SANTA MARIA PUBLIC AIRPORT DISTRICT BOARD OF DIRECTORS

- 6. AUTHORIZATION FOR THE GENERAL MANAGER TO EXECUTE CHANGE ORDER NO. 1 & 2 FOR THE U.S. CUSTOMS UPGRADES: BUILDING & SITE CIVIL BETWEEN THE DISTRICT AND NEWTON CONSTRUCTION & MANAGEMENT, INC.

US Customs Remodel Change Order No. 1

Santa Maria Airport Change Order No. 1

RFI #9: Shutoff for Domestic Water Line Entry

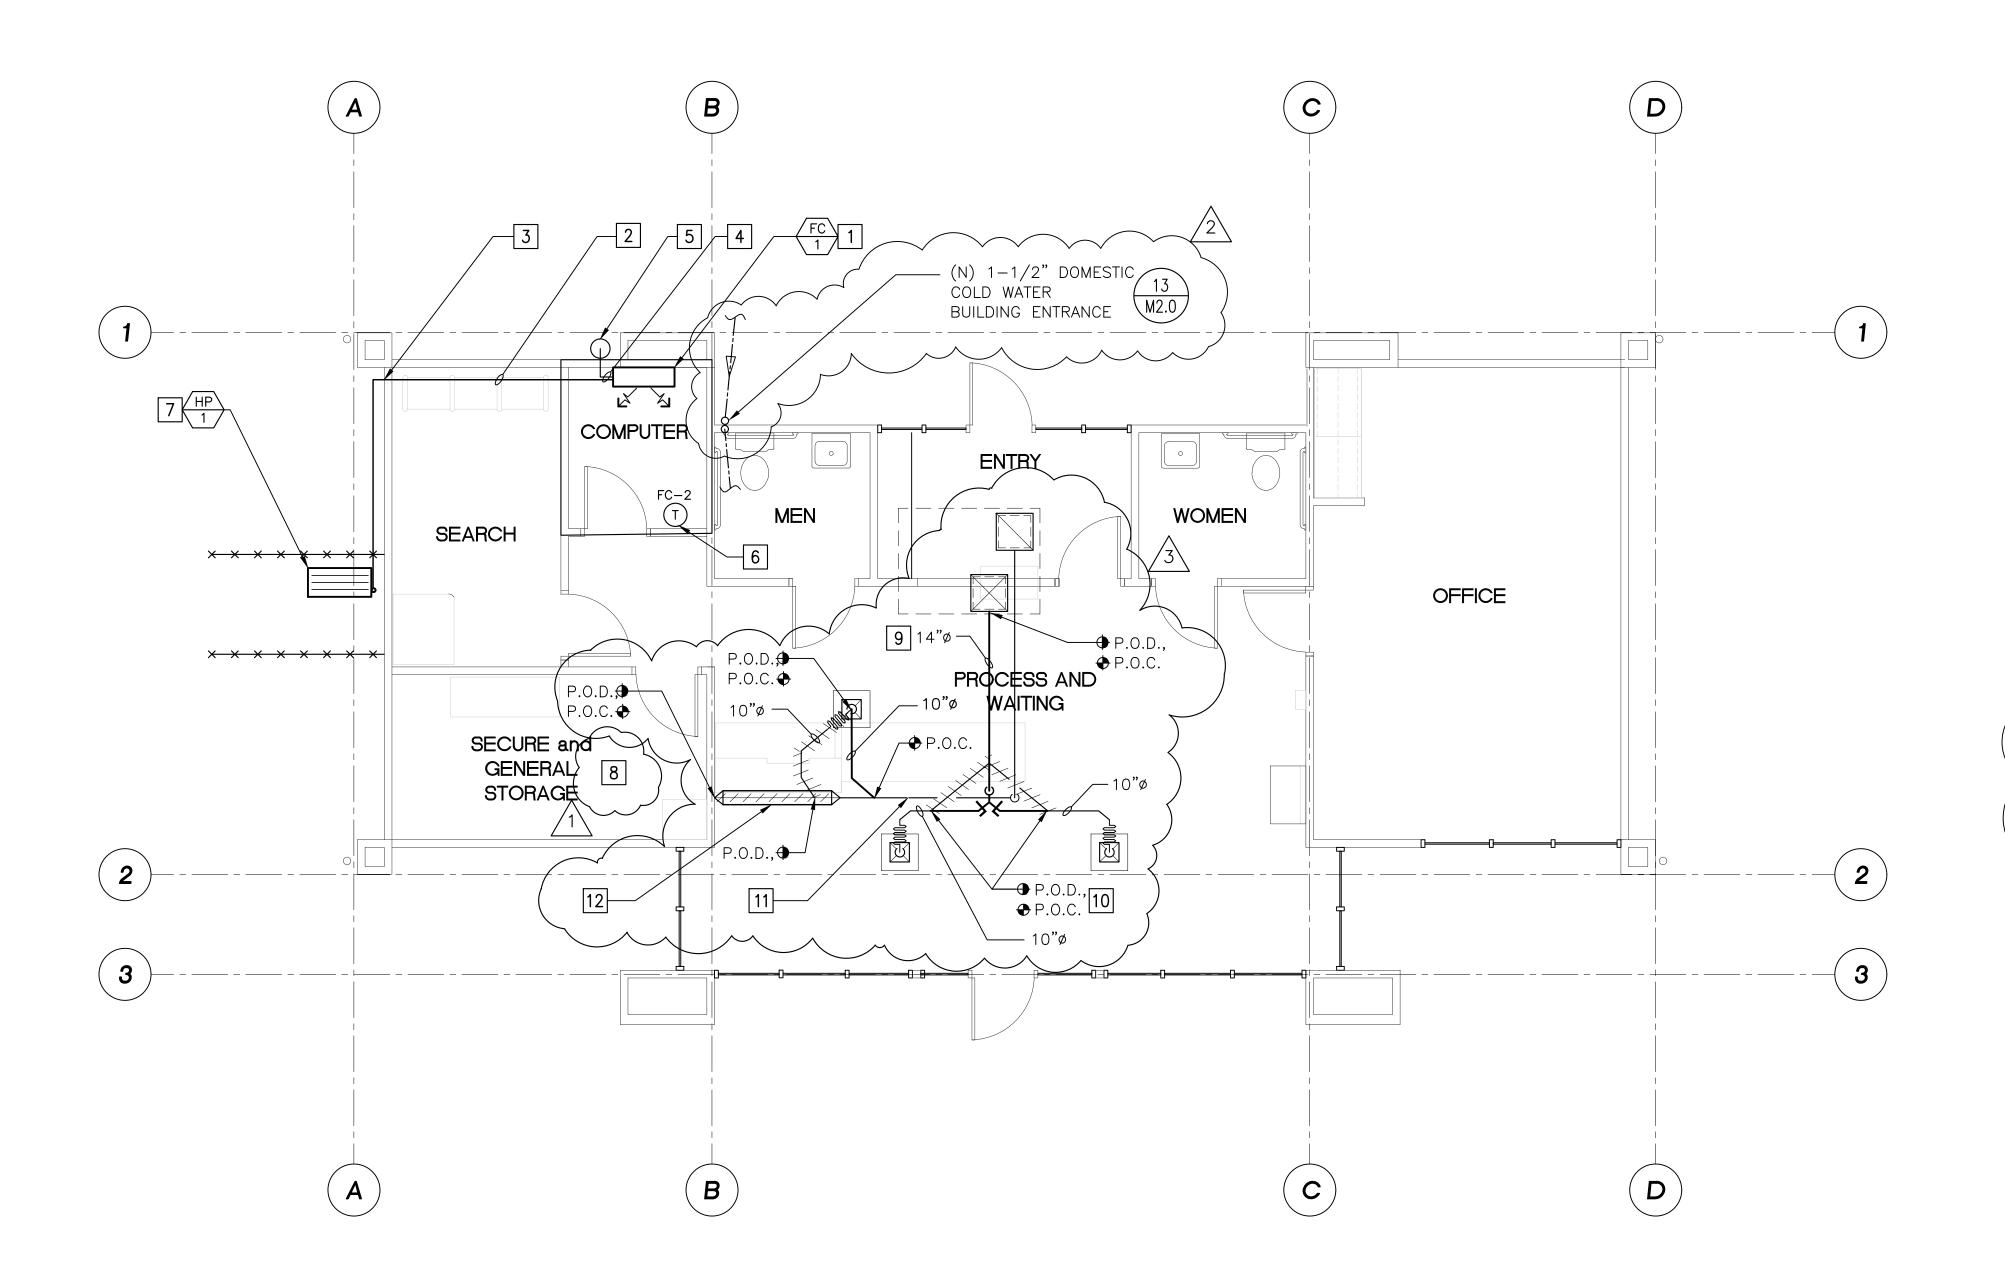
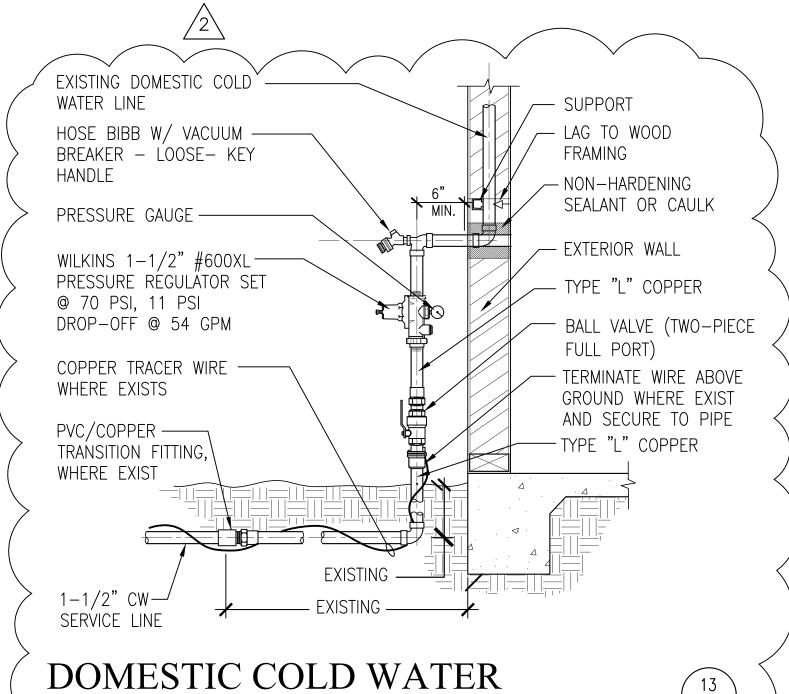
Per the attached photo, the point of entry for the domestic main water line does not have a shut off valve or pressure regulator. Please confirm if one or both of these items is to be added and provide specifications for submittal purposes.

See revised drawing sheet M2-0, Revision 2. Add new shut off valve, pressure regulator and hose bib/building drain valve per detail.

RFI #16: Power for Bathroom Sink Hand Dryers

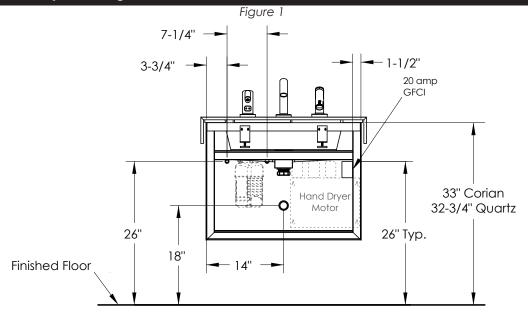
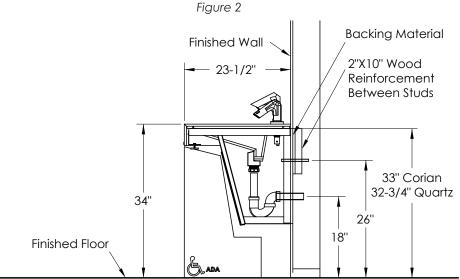
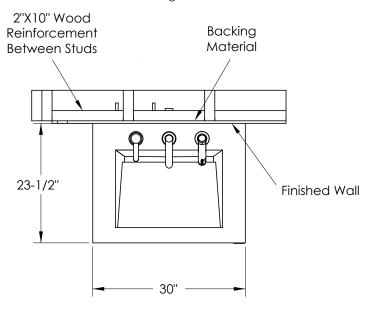
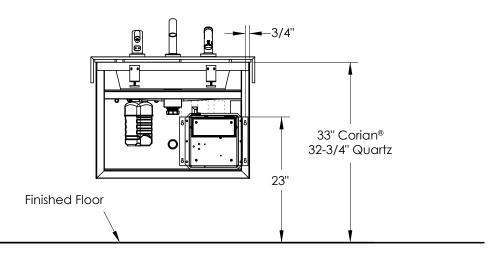
DESCRIPTION: Pursuant to the response from RFI 16, NCM proposes to furnish and install power sink built in hand dryers in each of the two bathrooms.

Provide new 20 amp , 1 pole circuits with 2 #12 and 1 #12 ground in 1/2 Conduit from Panel A, 1 per hand dryer. Utilize existing circuits and circuit breakers (example 5, 6) made spare from installation of panel A-UPS. Provide receptacles or hard wire connection per hand dryer manufacturer's instructions. Include designation of new hand dryer circuits on updated panel schedule card.

RFI #19: Existing Ducting Clashing with New Lighting

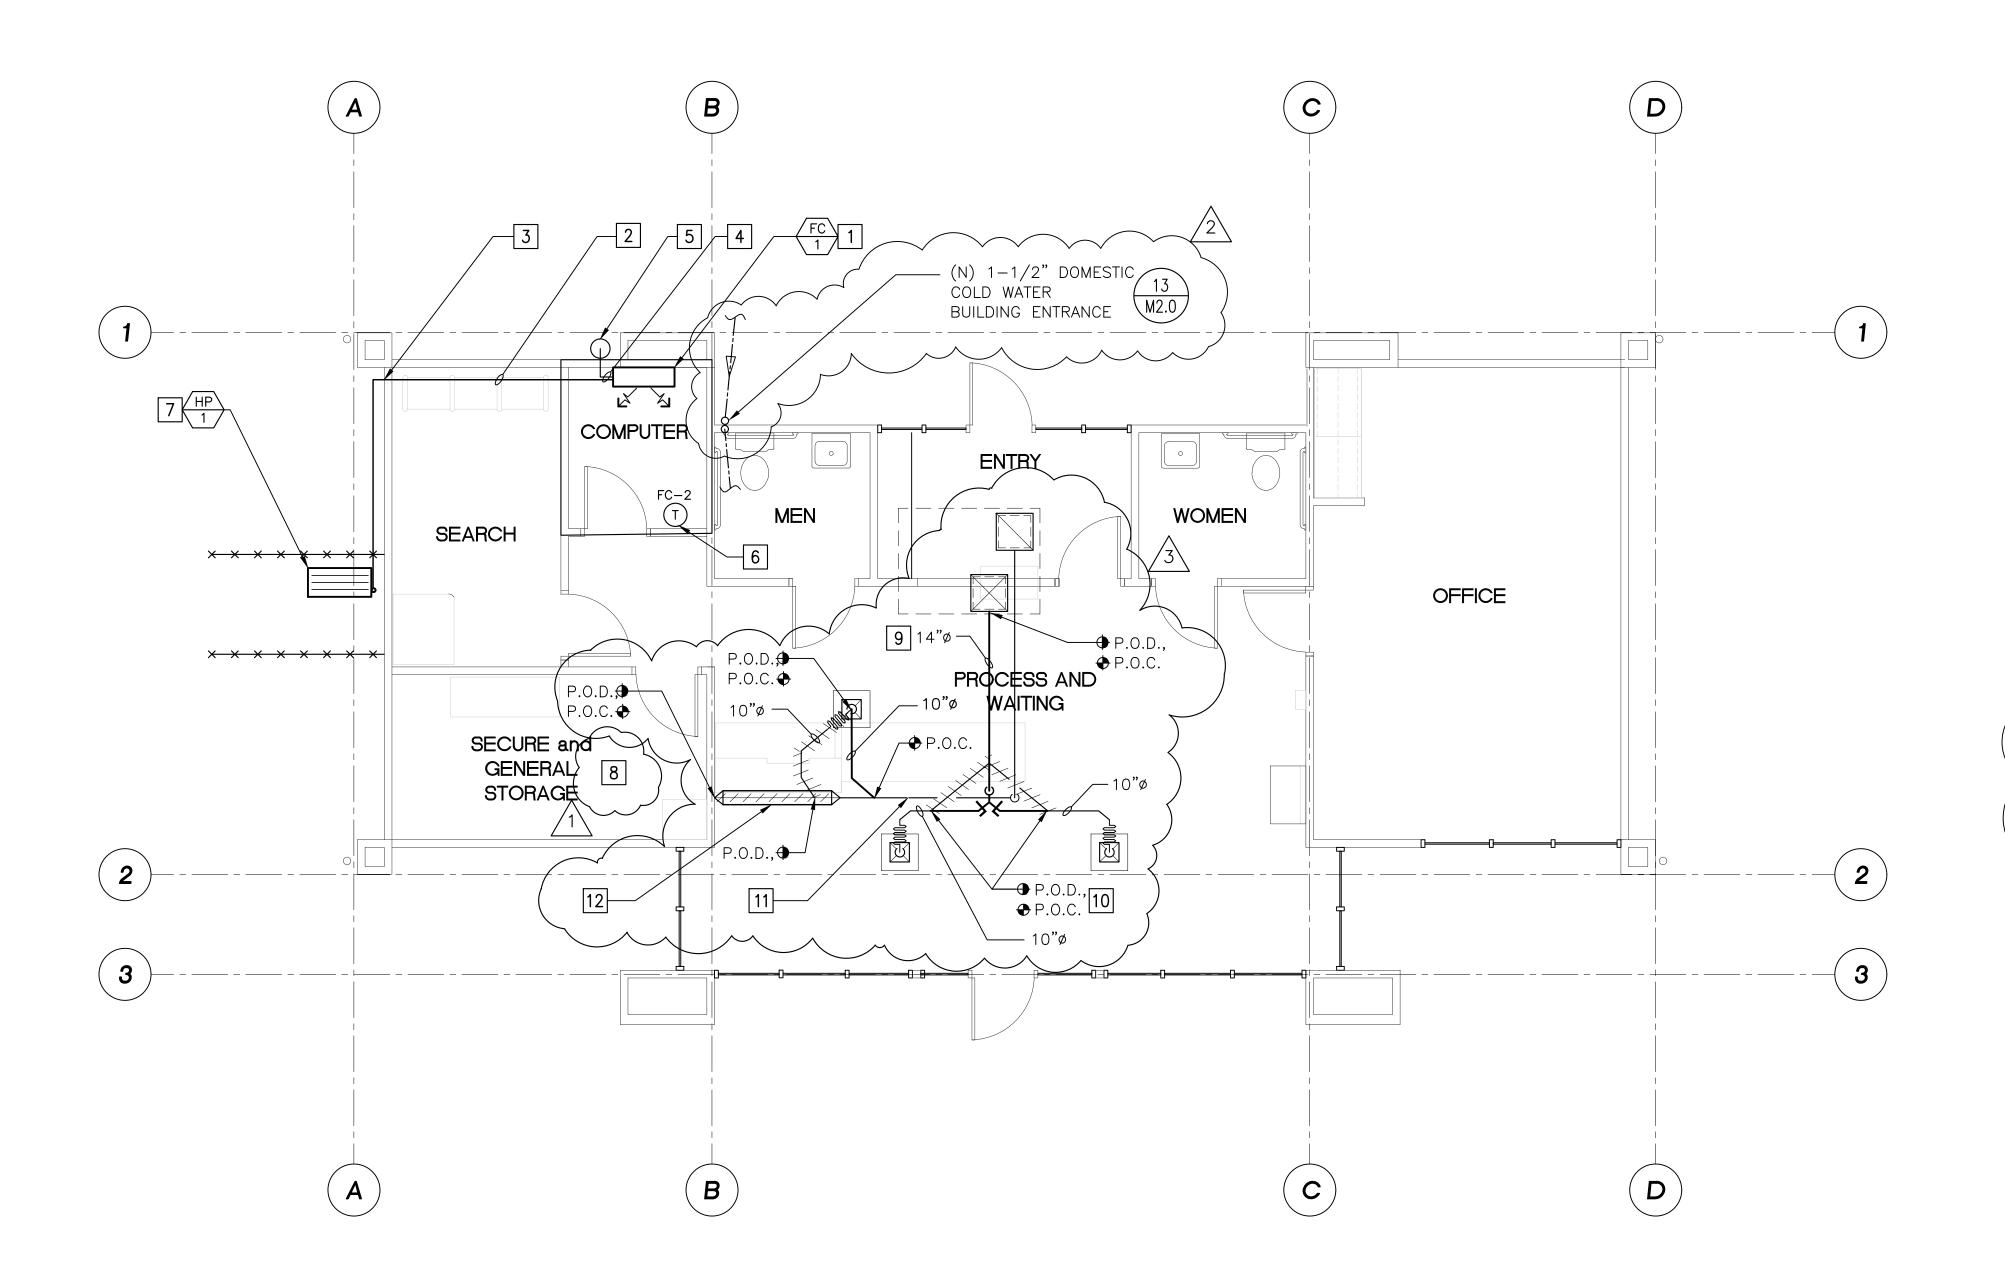
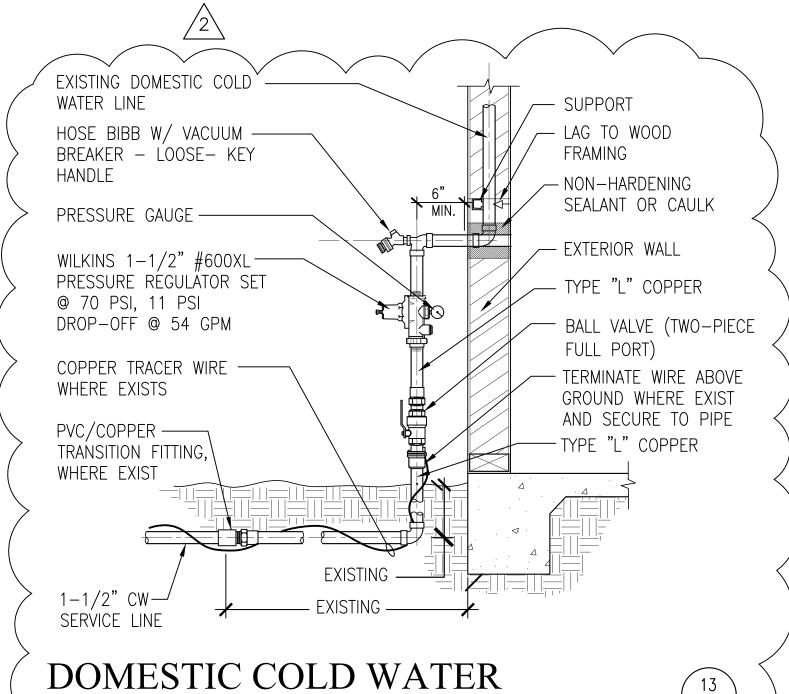
Please confirm acceptable to change out existing 12" spiral duct return to a 6"x22" rectangular duct to allow space for the new acoustical ceiling and new lights or advise otherwise.

See attached sheet M2.0 Revision 3. Relocate supply ductwork up into joist space cavity similar to return ductwork. Replace section of return duct with rectangular duct to flatten.
